Comment Resolution Status

Document: T10/01-328r7

To: T10 Committee Membership
From: Cris Simpson, Intel Corporation
Subject: Response to T10 Letter Ballot comments on SRP

Figure 0.1 - IB I/O unit example

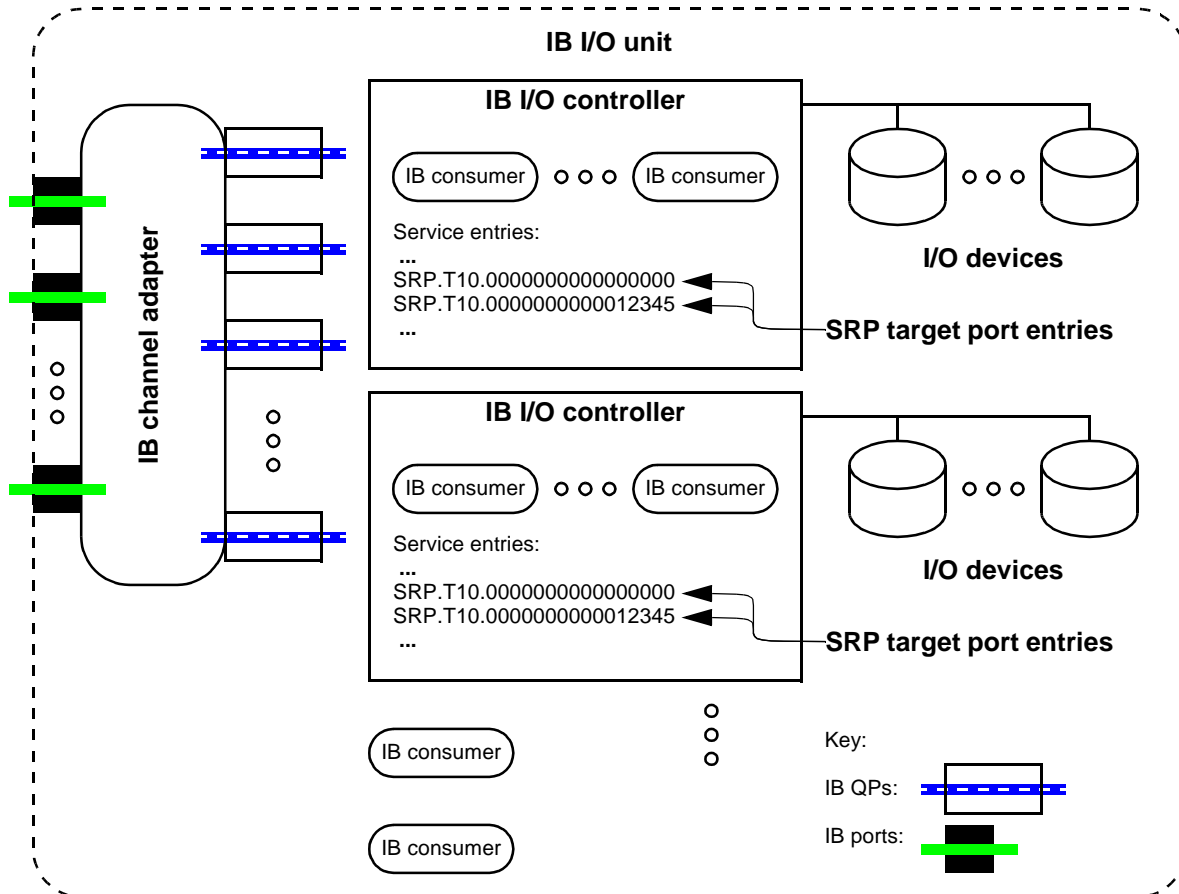
Figure B.3's equating of 'SRP Target Ports' with 'IB consumers' is problematic. A 'target port' is a sort of service access point---somewhere where interested parties initially go to obtain service, but without any implication that that's where the service is actually provided. (In IB, it's the Connection Manager that receives the initial connection request, interprets the ServiceID contained therein, and performs some magic that results in the instantiation of a QP bound to some entity that actually provides the target services). This target-services-providing entity fits the definition of 'IB consumer'. But the mapping of ServiceIDs-cum-SRP target ports onto such entities is clearly a matter of implementation, and could be one-to-many, many-to-one, or many-to-many Suggested Solution: One possibility: to the left of the IB Consumers show a table/list of service IDs within each IB I/O unit and label these entries as SRP Target Ports; use arrows to show a mapping from the entries to the IB Consumers, with e.g. one Consumer mapped to two IDs and another mapped to one ID to show that the mappings are not always 1 to 1. A further refinement might be to use another set of arrow between the Consumers and the QPs to show that the this mapping is also not 1 to 1

Notes from 28 Nov 2001 teleconference: show service entries in figures B.2 and B.3, in accompanying text explain that each service entry identifies an SRP target port.

This comment is correct, but it's not immediately obvious how to incorporate it into a legible diagram. Note the further complication introduced by connection redirection. The IB consumer (IB QP and the software, etc. behind it) may be in an unrelated device / node / whatever, it need not be the same channel adapter or even an I/O unit. The sole purpose of the I/O unit and I/O controller is to obtain a service ID, connecting to that service ID may lead somewhere else altogether.

The following is an attempt at a modified figure B.2 and the text describing service entries that identify SRP target ports

One or more service entries are associated with each IB I/O controller. A service entry contains a name and other information identifying an individual service provided by the IB I/O controller. A service entry may identify an SRP target port or a non-SRP service (e.g. a network interface service). Requirements for service entries that identify SRP target ports are described in table B.8.
